DELEGATED REPORT

FILE: OPW/22/0006 (Stage 3)

The development application seeks a Development Permit for Operational Works (Road work, Stormwater, Water infrastructure, Drainage work and Earthworks for Stage 3 (5 Lots) of Development Permit REC/07/0074) - **The Rise Stage 3**

THE RISE ESTATE RURAL RESIDENTIAL SUBDIVISION STAGE 3 OPERATIONAL WORKS DRAWINGS

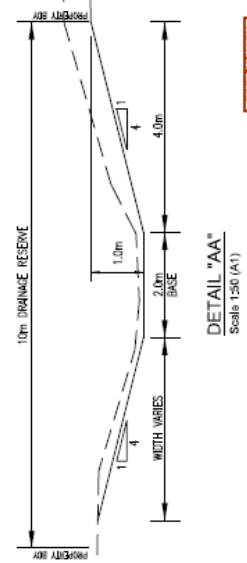
Prior to the pre-start meeting occurring, amended stormwater drainage plans must be submitted to Council for review and endorsement by Council's delegated officer. The amended stormwater drainage plans must include the following details:

- (a) A 2 metre wide reinforced concrete invert drain, with a minimum thickness of 150mm must be installed for the full length of the large drain at the rear of Lots 1, 2 and 3 in order to protect the drain from future scour and ensure ease of maintenance for responsible landowners.

- (b) Water slowing devices (number, design and location to be approved by Council's delegated officer) must be included within the drain to ensure that water velocity is adequately reduced so as to not cause damage to any part of Lot 209 on SP306259.

- (c) Rock protection must be included on the outside edge drain batters at any bends in the drain to reduce the risk of scour.
- (d) A 1 metre wide concrete invert drain must be included along the full length of the smaller open drain running through Lot 3. Where this drain discharges into the larger drain a water slowing device must be installed to ensure that water velocity is adequately reduced before being discharged into the larger drain. Alternatively, the end of the Lot 3 drain can be redesigned, and concrete sealed so as to direct water into the larger drain in a downstream direction instead of perpendicularly. In either case, rock protection must be installed on both batters of the larger drain at this discharge location to protect against scour.

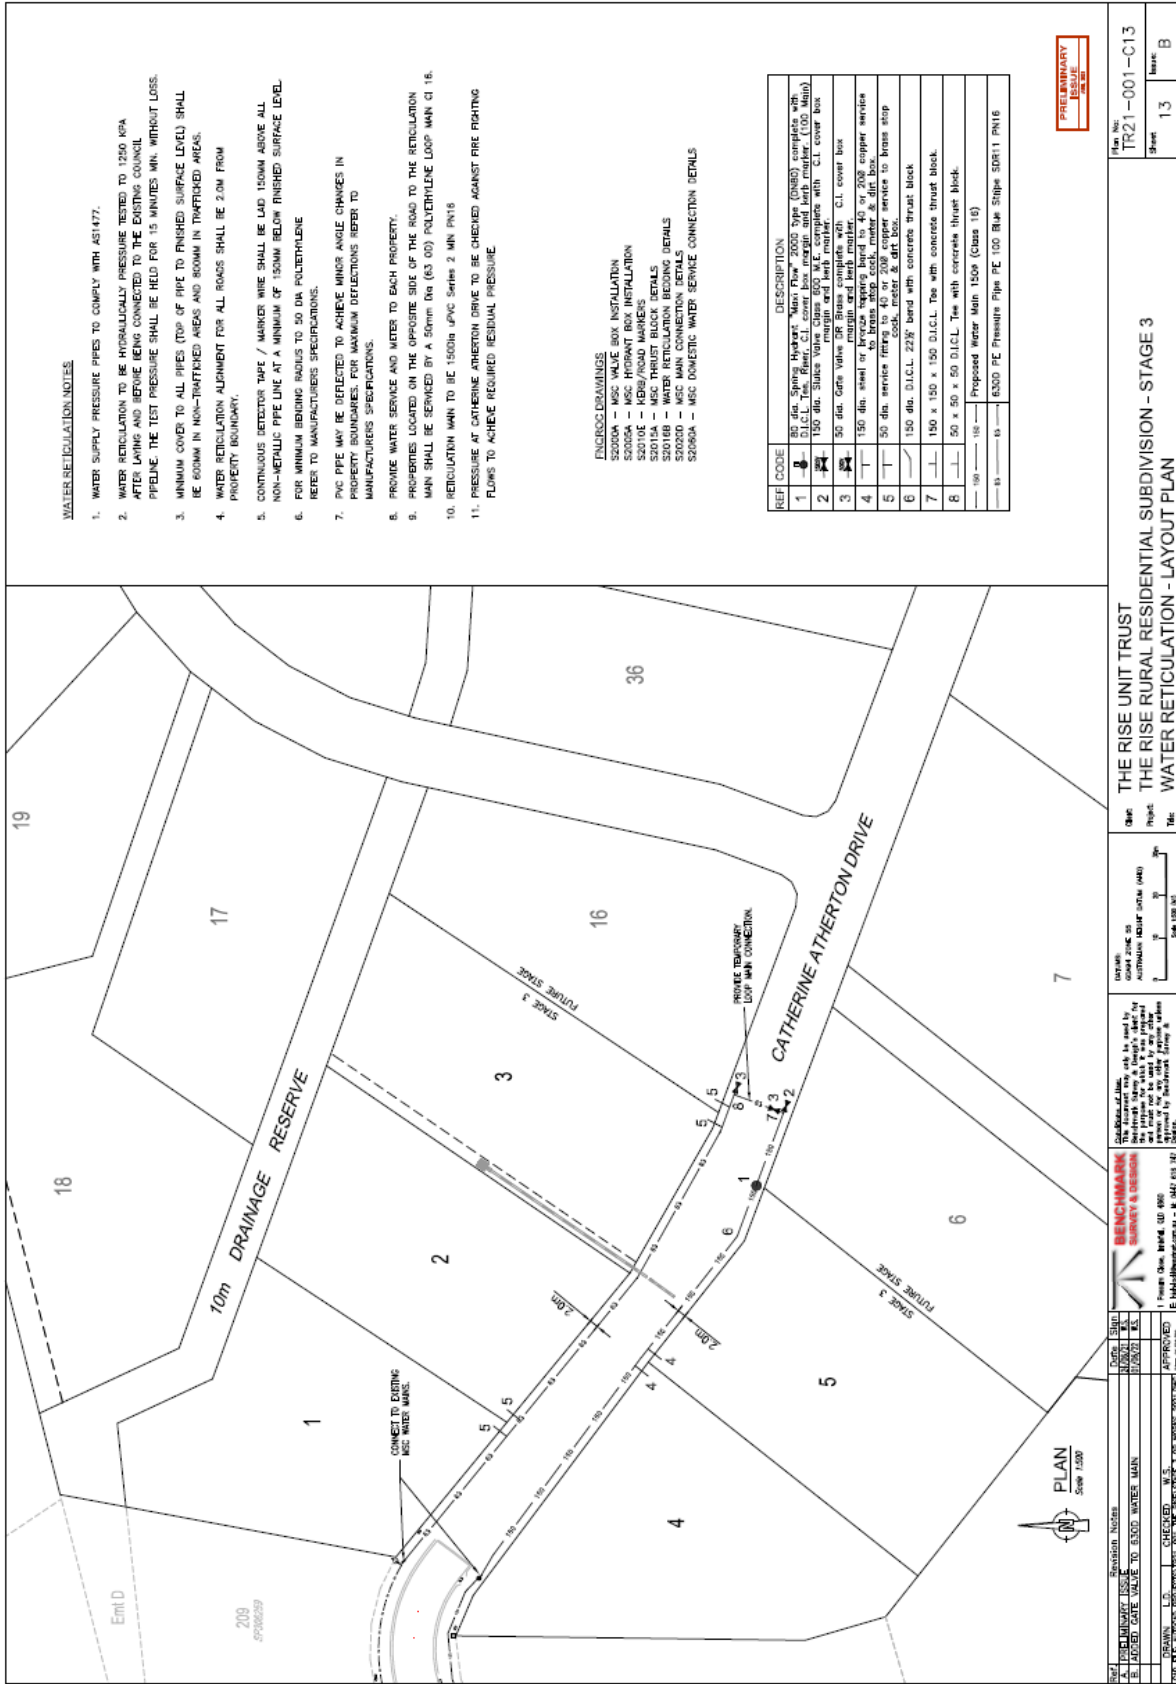
- (viii) The 'temporary loop main connection' shown on drawing C13 must be installed using ductile iron piping (DICI) and must be maintained as a permanent component of the water supply network.
